**From:** Eldon McIlwain <Eldon.McIlwain@gov.ab.ca>  
**Sent:** Monday, July 10, 2017 6:56 PM  
**To:** Contact, Commissioner (COMM)  
**Cc:** MN\_COMM\_Pipeline Comments; Doug Lammie; Carrie Clifford; ryan loney  
**Subject:** Government of Alberta Technical Submission  
**Attachments:** Technical Submission.docx; Government of Alberta - Minister Letter.pdf

On behalf of the Minister of Energy for the Government of Alberta, attached please find our written comments on the Draft Environmental Impact Statement in support of the Enbridge Line 3 Replacement Project.

CN-14-916 and PPL-15-137

**Figure ES-9.**

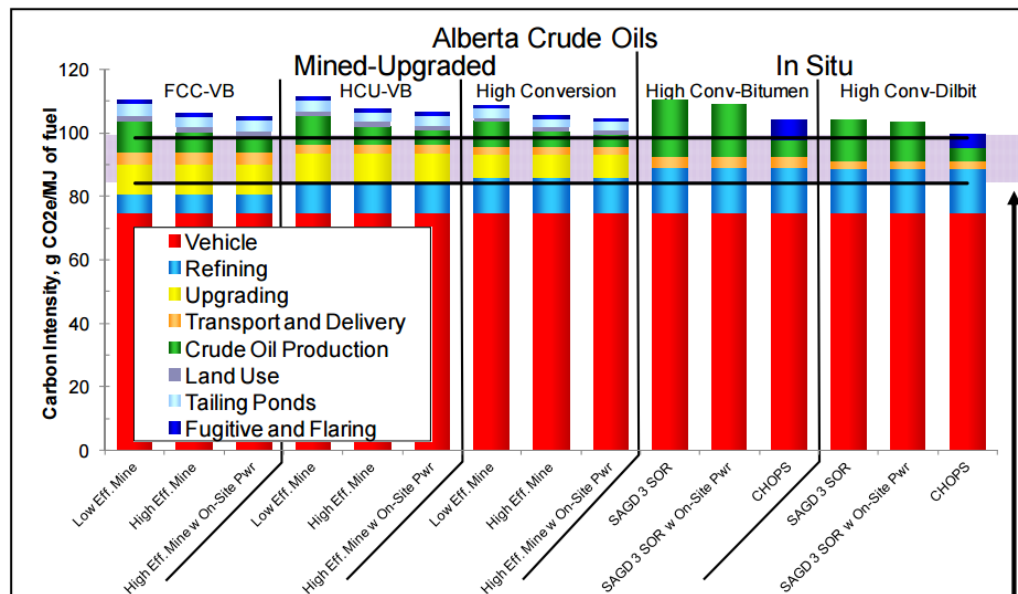
- A range of GHG intensities exists for heavy WCSB crude oil, in part due to processing technologies, as seen in Figure ES-9 below.<sup>4</sup>

**Table 5.2.7-11 Average Life-Cycle Greenhouse Gas Emissions for Various Crude Oils**  
Adapted from original with Government of Alberta calculations (Row 2, 3 and 4)

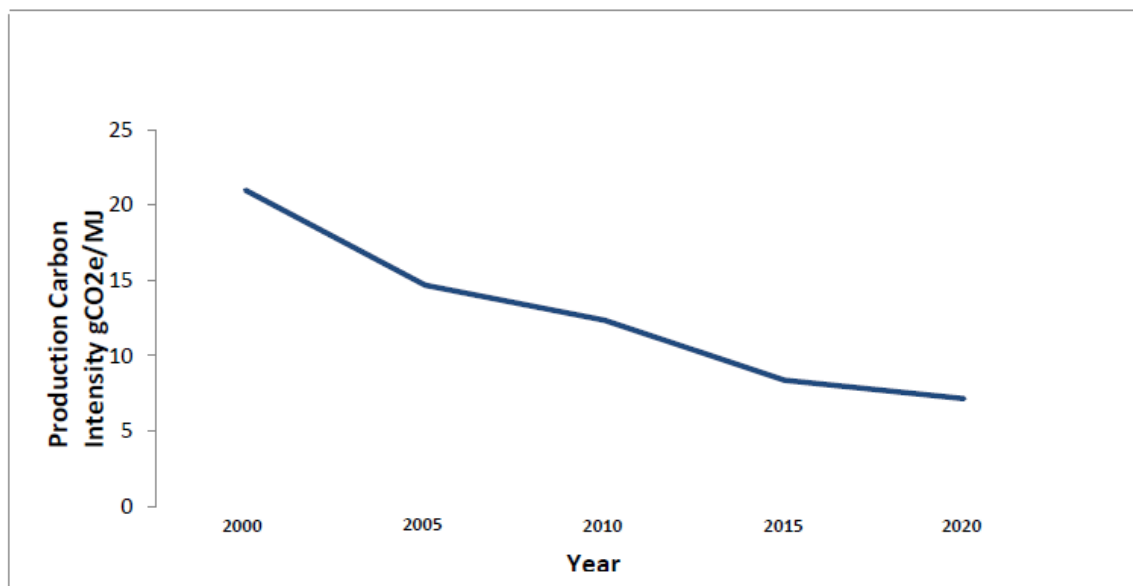
The Government of Alberta also recommends the Department add another displacement scenario in Table 5.2.7-11, where 760,000 barrels per day (bpd) of WCSB heavy crude oil displaces the 390,000 bpd of WCSB light crude oil from the existing Line 3 and 370,000 bpd of Venezuelan heavy crude oil, as shown below. The 390,000 bpd of light crude oil volumes displaced on Line 3 would potentially displace heavy crude oil volumes elsewhere on the Enbridge Mainline or on the rail transport system. This displacement scenario could potentially alter the overall GHG emissions impact for the Line 3 project and can be found in the fourth row of the table below, where crude imported from Canada displaces crude imported from Venezuela<sup>[1]</sup>.

**Fig. 2**  
**Benzene Concentration in Plume vs**  
**Distance Downstream of Spill**

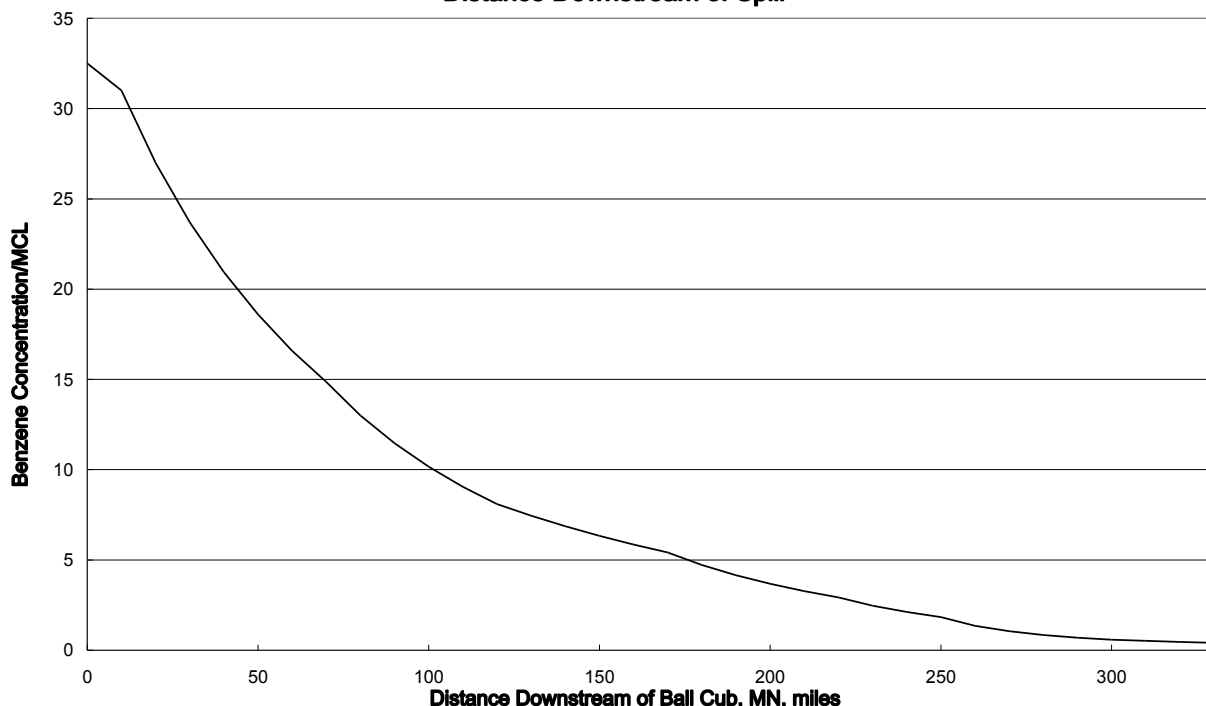
As seen in the Fig. 2 plot of concentration results, normalized to the benzene MCL, the plume would reach over 280 miles before its concentration would drop to the MCL and be safe for public water intakes.
